<b>Docket Number:</b>	18-BSTD-02
<b>Project Title:</b>	2019 ENERGY CODE COMPLIANCE MANUALS
<b>TN #:</b>	224401
<b>Document Title:</b>	NRMCA Comments Update R-value ICF products on CEC Appendix
<b>Description:</b>	N/A
<b>Filer:</b>	System
<b>Organization:</b>	National Ready Mixed Concrete Association (NRMCA)/Tien Peng
<b>Submitter Role:</b>	Public
<b>Submission Date:</b>	8/3/2018 2:54:18 PM
<b>Docketed Date:</b>	8/3/2018

## **Update R-value ICF products on CEC Appendix**

Figure 4.3.13 – Insulating Concrete Forms

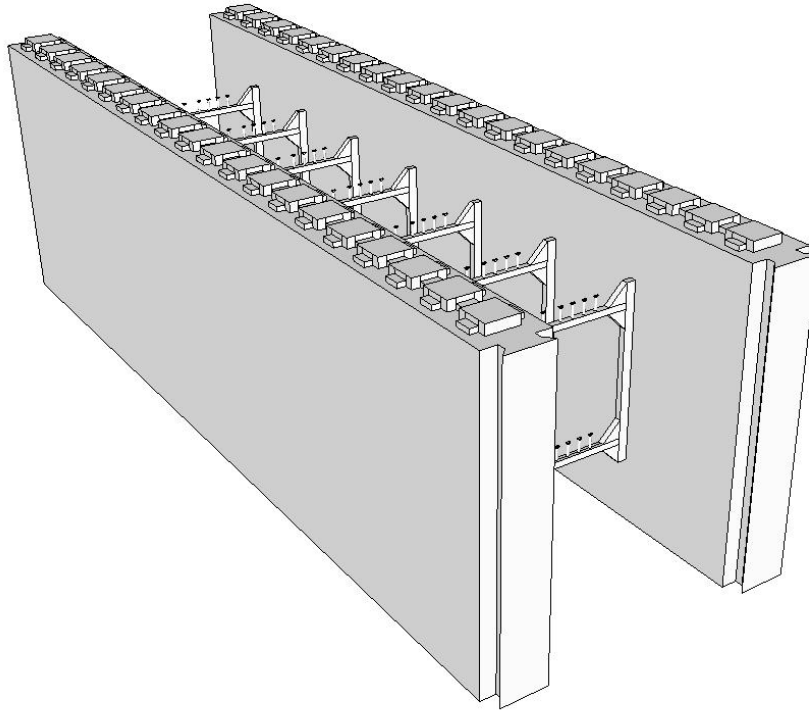
The National Ready Mixed Concrete Association (NRMCA) would like to submit updates to the 2019 Reference Appendices Table 4.3.13 “Thermal Properties of Insulating Concrete Forms by providing current thermal performance values for the foam being used in the wall assembly. I have attached a PDF version of the updated Table 4.3.13 which shows the edited U-factors, R-values, notes and assumptions highlighted in yellow. I have also attached supporting documents that show the calculations for the updated values and the ASTM C578 Type II EPS R-value per inch test data. Along with updating the tables values we would also like to submit updates to the 2016 Residential and Nonresidential Manuals to provide clarifying descriptions and photos of ICF construction. The attached Word document shows the existing language along with the proposed residential and nonresidential language for the compliance manuals. For the Residential Compliance Manual we would like to replace the existing language with the attached updated language. With the Nonresidential Compliance Manual we would like for the ICF description to be located after section 3.5.1 which will be similar to how it is presented in the Residential Compliance Manual.

This application comment was submitted previously and we were informed that the CEC is limited to using the minimal listed R-value that is shown the Bureau of Home Furnishings and Thermal Insulation directory (which are below the R-4 value noted here). The request is to decouple the CEC Appendix from the Bureau’s directory or have the Bureau take steps to update their out-of-date directory.

**Assumptions:** Values in this table were calculated using the one dimensional calculation method documented in 2009 ASHRAE Handbook of Fundamentals. The calculations assume an exterior air film of R-0.17, a 7/8 inch layer of stucco of R-0.18, an exterior insulating form of varying resistance, a concrete core of varying thickness at R-0.11 per inch, an interior insulating form of varying resistance, 1/2 inch gypsum wallboard of R-0.45, and an interior air film of R-0.68. The R-value of the cement/EPC compound is assumed to be R-3.0 per inch, the XPS insulation assumed to be R-5.0 per inch, and the polyurethane assumed to be aged and dried in 1.5 inch, 2.0 inch, and 4.5 inch thickness.

**Figure 1: ICF Wall Construction**

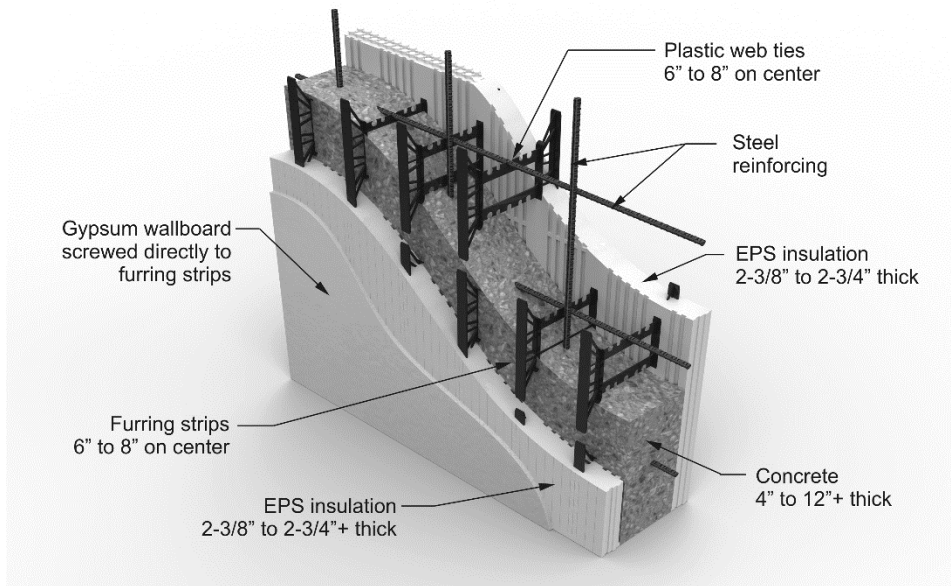
~~Plastic or metal~~ cross-ties, consisting of two flanges and a web, separate the insulating panels and provide structural integrity during the pouring of concrete, resulting in a uniform wall thickness (see Figure 1). A variety of wall thicknesses can be obtained by changing the length of the web. The area of attachment of the cross-ties to the insulating form provides a secure connection surface located at standard spacings for mechanical attachment of finished materials to the interior and exterior of the wall. ICF can be used to construct load-bearing and non-load-bearing walls and above- and below-grade walls, and can be designed to structurally perform in any seismic zone.
